NOTICE OF DECISION

DECISION OF THE PLANNING COMMISSION

**CLASS 3 DESIGN REVIEW / CLASS 3 SITE PLAN REVIEW / CLASS 2
ADJUSTMENT / CLASS 2 DRIVEWAY APPROACH PERMIT CASE NO.:
~~DR-SPR-DAP-ADJ20-04~~ DR-SPR-ADJ-DAP20-01**

REQUEST: A consolidated application for the redevelopment of the YMCA (recreational and cultural community service) consisting of the proposed three-story, 53,599 square foot building and vehicle use area, and modifications to driveways on Cottage Street and Chemeketa Street. The application includes the following:

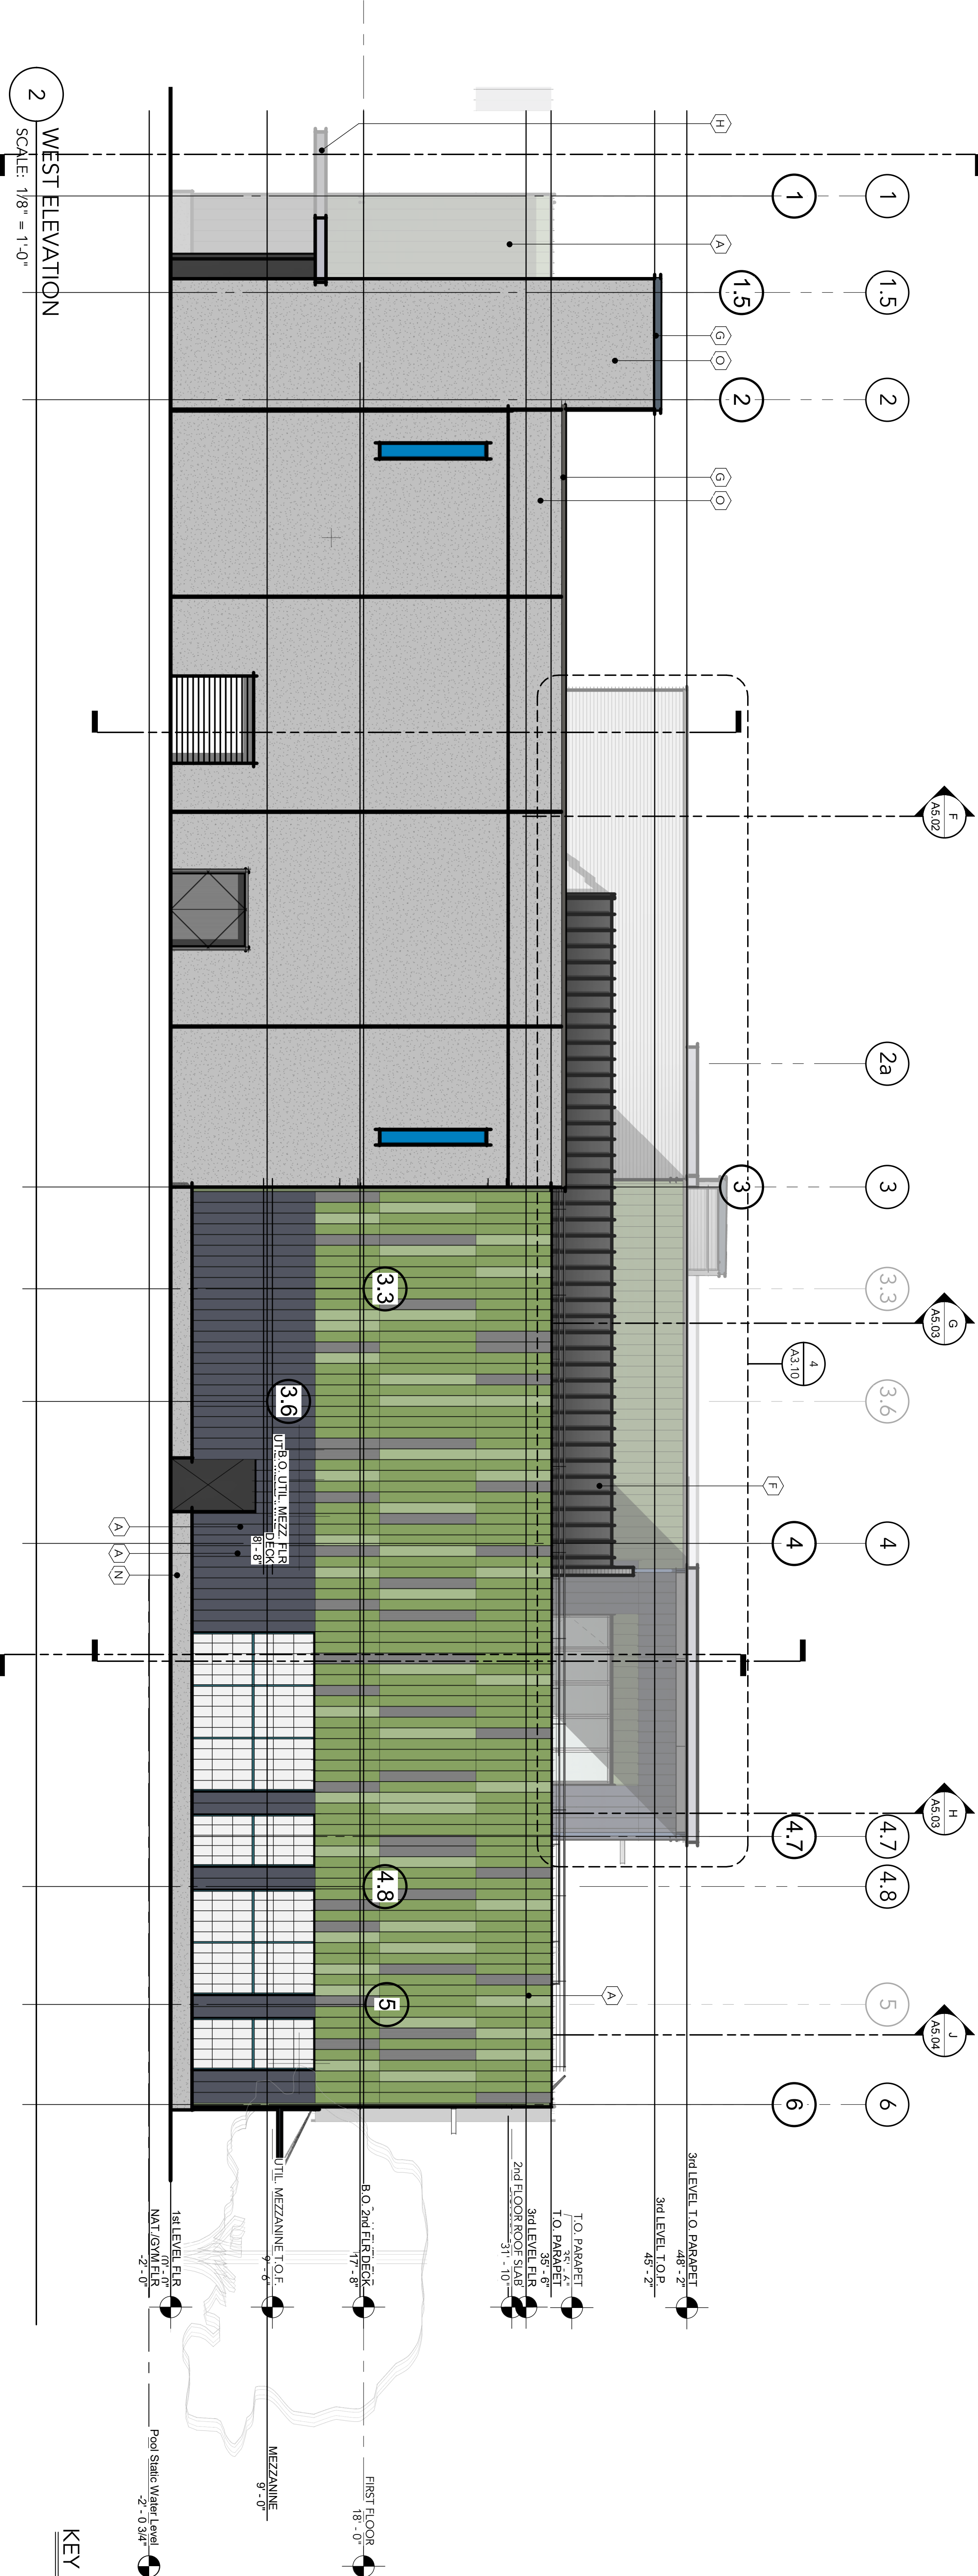
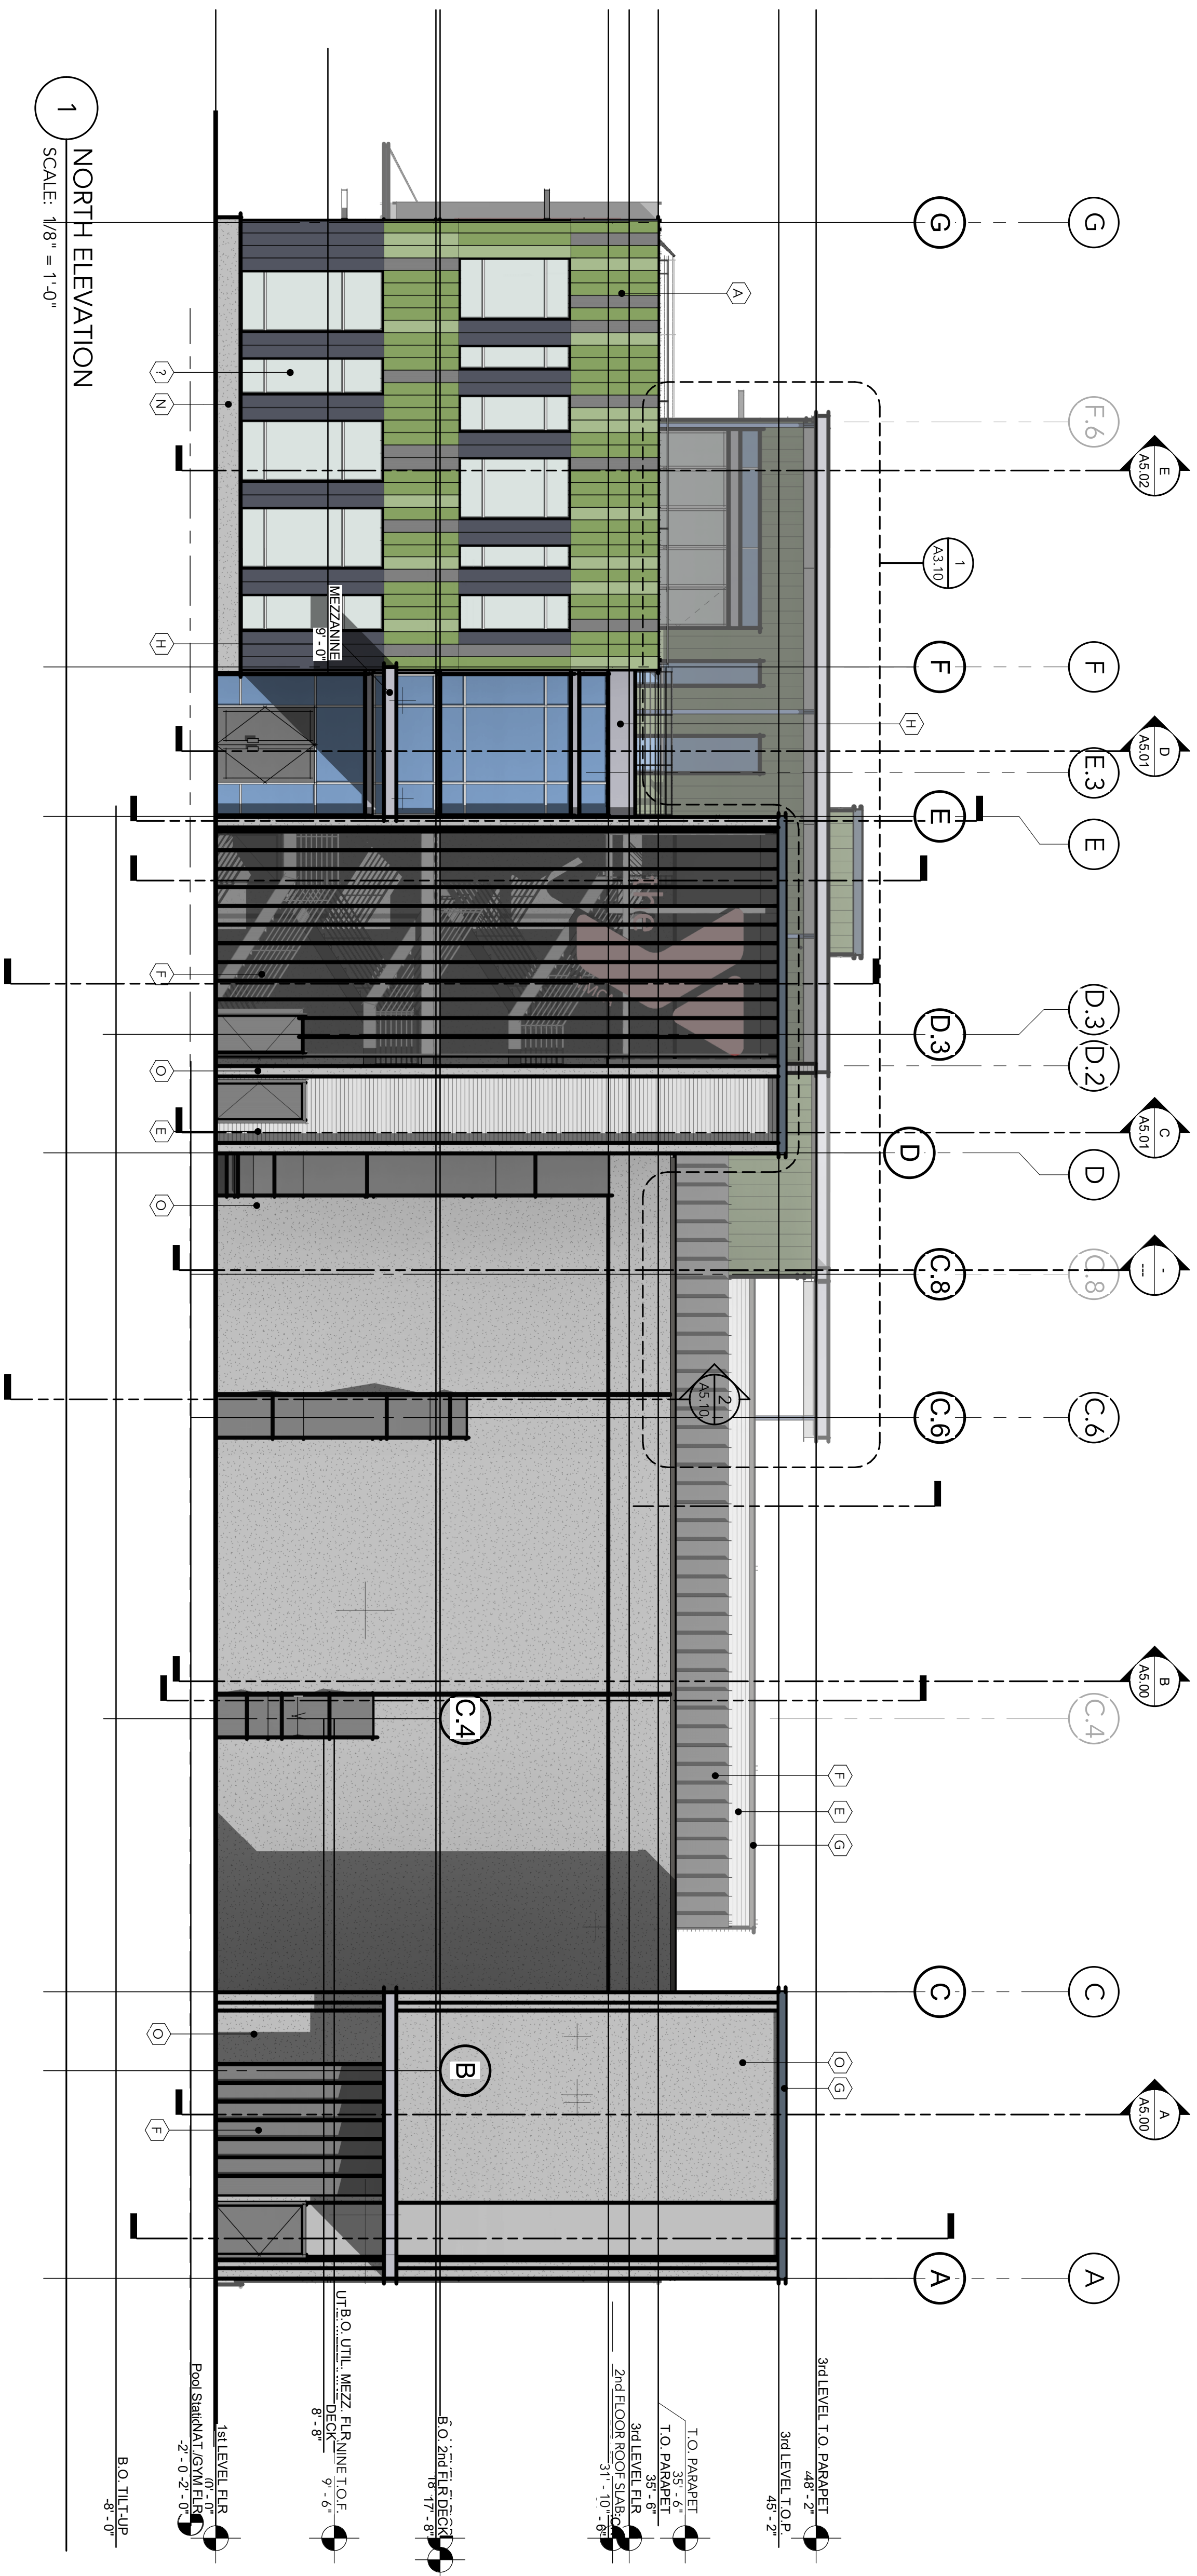
- **Building Setback Abutting Street.** As summarized in the table above, the CR zone requires buildings to be setback 5 ft. from the property line abutting the street. As shown on the site plan, the proposed building has a varying setback adjacent to the street. In some locations the building is constructed contiguous to the property line abutting the street and in other locations the building is setback between 9 ft. and 54 ft. Since the entire building is not proposed to be set back 5 ft. from the street right-of-way, the building does not meet the building setback from the street required by in the CR zone; instead, the building has been designed to conform to the General Retail/Office Overlay Zone design guidelines that call for building setbacks from the street to be minimized. Because the CR zone street setback requirement is not met, a Class 2 Adjustment to this standard has been requested in conjunction with the proposal.

As shown on the site plan, the vehicle use area is proposed to be 0-feet from the east property line abutting Cottage Street NE, where six to ten-feet is required and the vehicle use area is proposed to be two-feet from the north property line abutting Chemeketa Street NE, where six to ten-feet is required. Because the proposed surface parking lot/vehicle use areas adjacent to the east and north property lines do not meet the minimum required setback, a Class 2 Adjustment to this standard has been requested as part of the application.

Development Site 15 percent. The applicant has provided as part of the site plan that the development site is 47,108 square feet, which requires 7,066 square feet of landscaping. The applicant is proposing 2,355 square feet or five percent of the development site. Because the proposal does not meet the minimum landscaping requirement, a Class 2 Adjustment to this standard has been requested as part of the application and is addressed below.

As shown on the proposed site plan, the proposal will include a total of eleven standard sized parking spaces and 28 compact sized parking spaces. The 34 compact spaces provided represents 74 percent of the overall 38 spaces provided; therefore, not exceeding the maximum 75 percent limit.

As shown on the site plan for the proposal, both standard size and compact size parking stalls are provided. The standard size stalls conform to the minimum required 9-foot width and 19-foot depth. The compact size stalls conform to the minimum required 8-foot width outside of the proposed parking garage and the minimum 8-foot 6-inch width inside the parking garage where compact stalls are located next to posts. The compact stalls also exceed the minimum 15-foot stall depth.

As shown on the site plan for the proposed development, the solid waste service area is uncovered, enclosed by a six-foot-tall perimeter wall, has an interior dimension within the enclosure of approximately 18ft in width by 12ft depth, has a front opening of 12 feet, and is free of vertical obstructions above the receptacles.

Condition 2: The trash/recycling area shall conform to the solid waste service area standards of SRC 800.055.

Condition 6: All landscaping provided shall meet a minimum of one plant unit per 16 square feet of landscaped area. The landscaping plan shall provide at least 40% of all plant units in shade trees.

Condition 7: Any plant units designated to trees abutting the streets shall be 'Shade Trees'.

OVERALL EXTERIOR ELEVATIONS

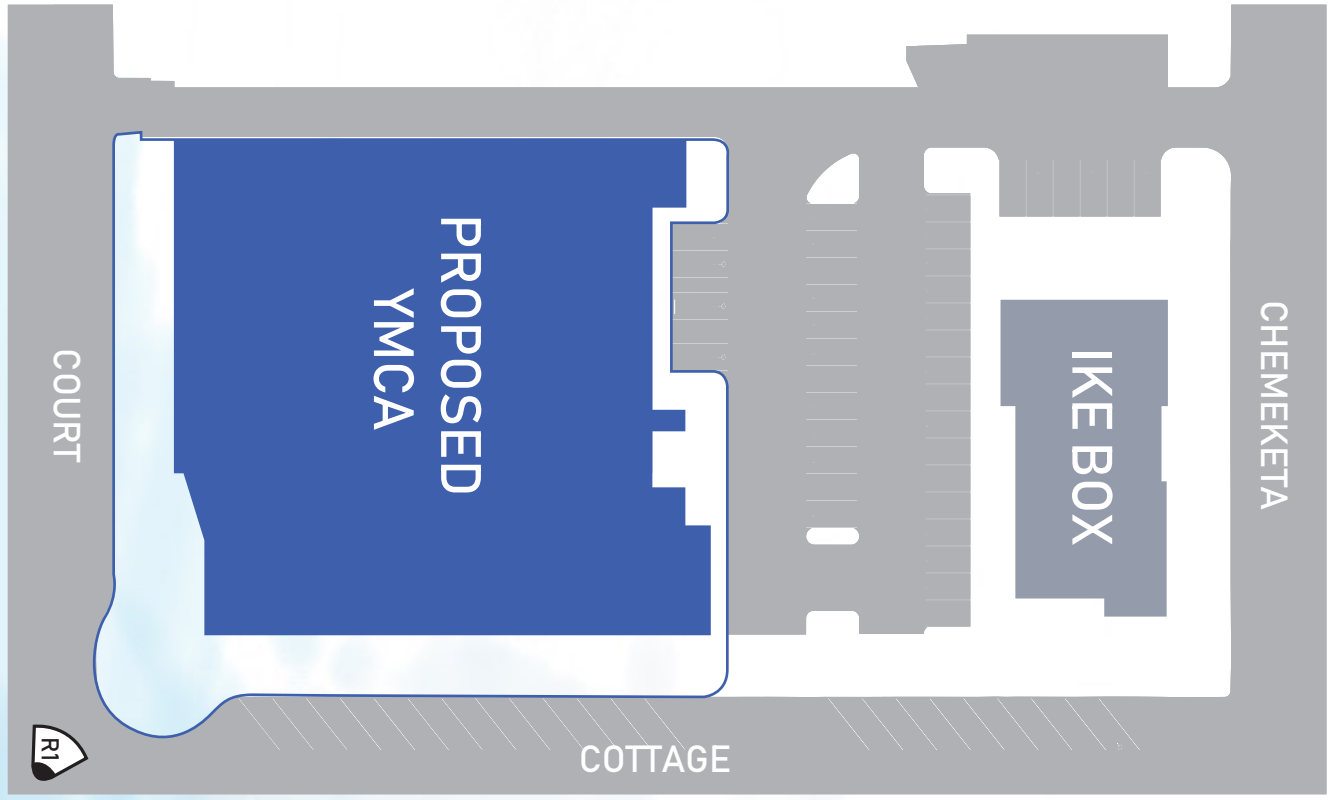
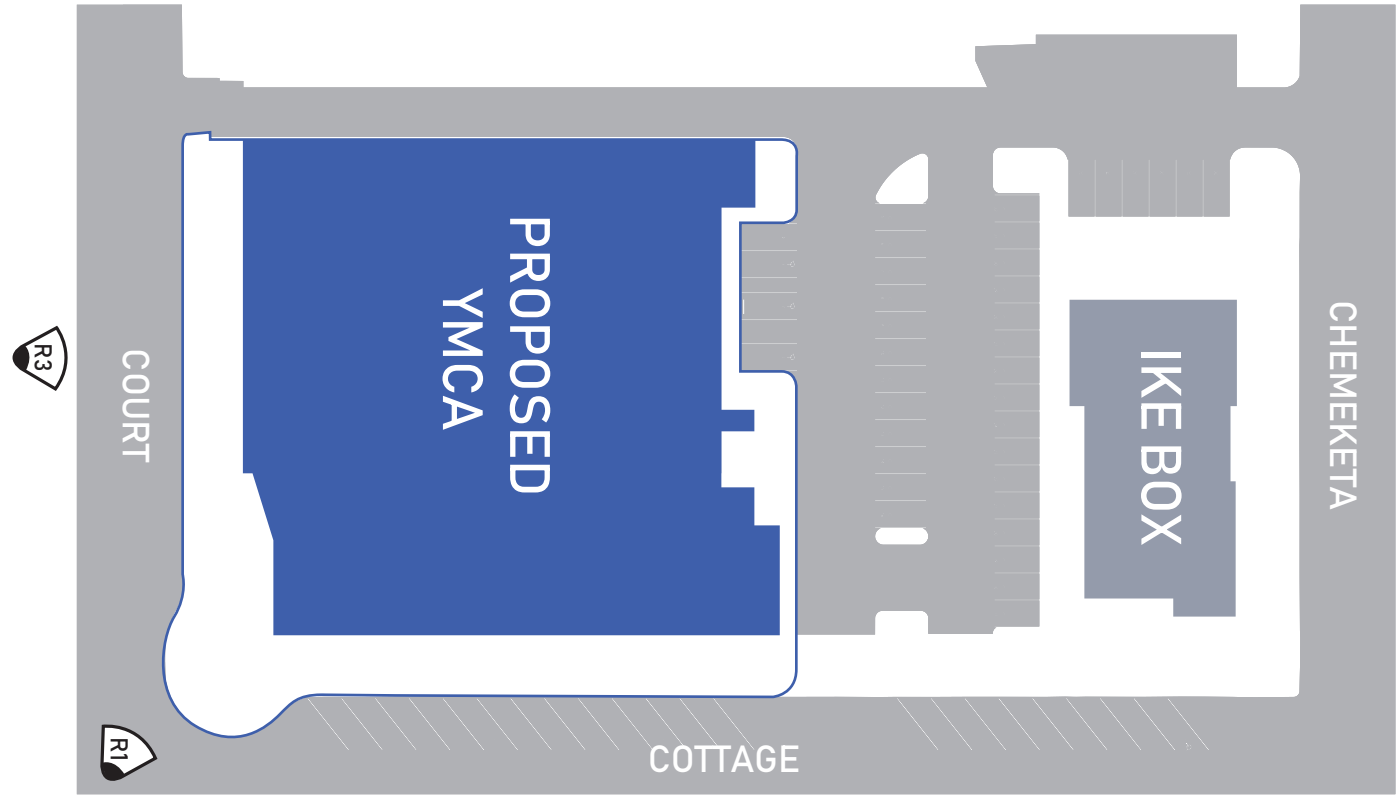
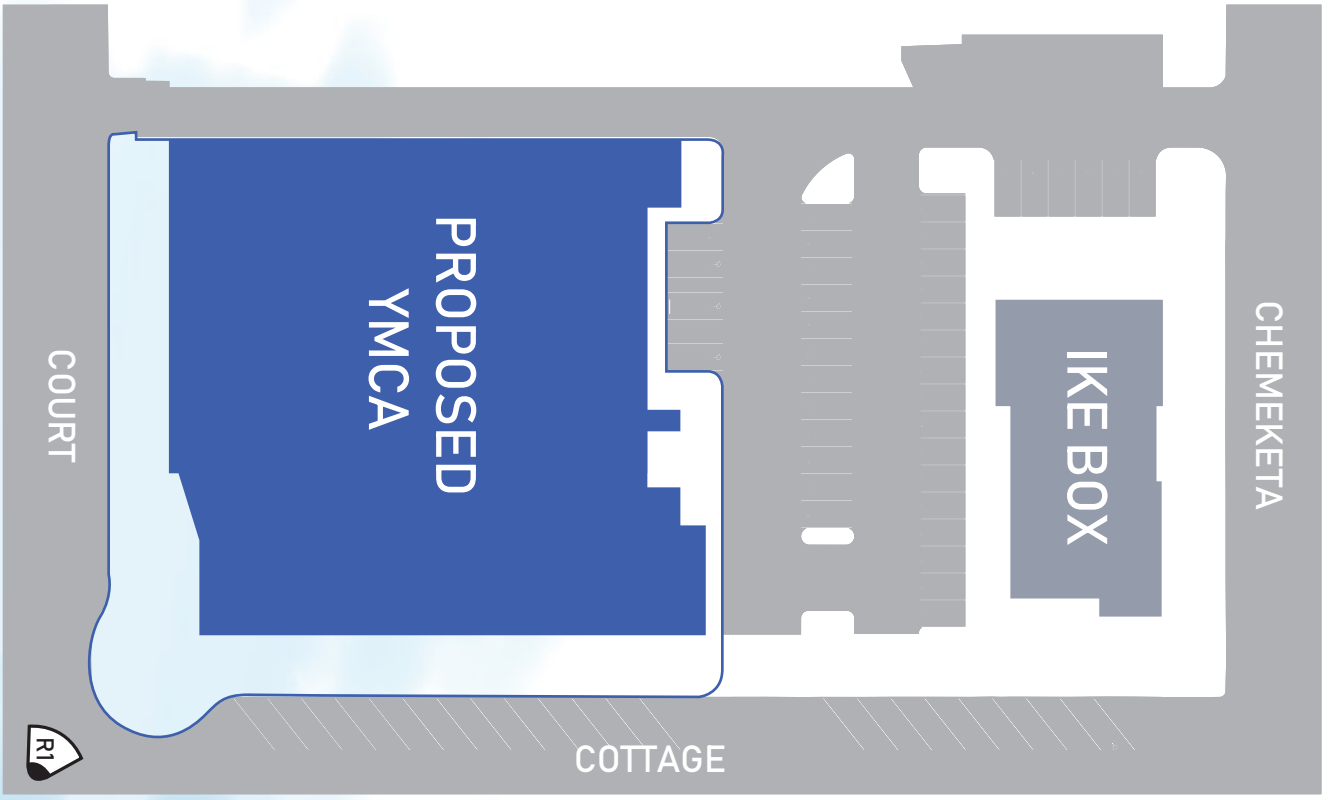
Finding: The written statement provided by the applicant (**Attachment D**) indicates that awnings along the façade facing Cottage Street NE will be provided, which is approximately 75% of the façade. The awnings along Court Street NE, along with the recessed entrance will be provide at approximately 45% of the façade, although the building has a recessed entrance which will provide weather protection to pedestrians entering the building. If the recessed area is added the weather protection is 75% of the Court Street frontage.

Staff concurs with the findings included in the applicant's written statement. The intent of the weather protection required under this design guideline is to provide protection from the sun and rain in order to ensure a comfortable and inviting environment for pedestrians along the sidewalk. The location of the building will be inviting to pedestrians and the proposal does provide cover over entrances to the building. The proposal conforms to this design guideline.

Condition 1: The proposed building shall have 65% of ground floor windows be transparent and shall not be mirrored or treated to block visibility.
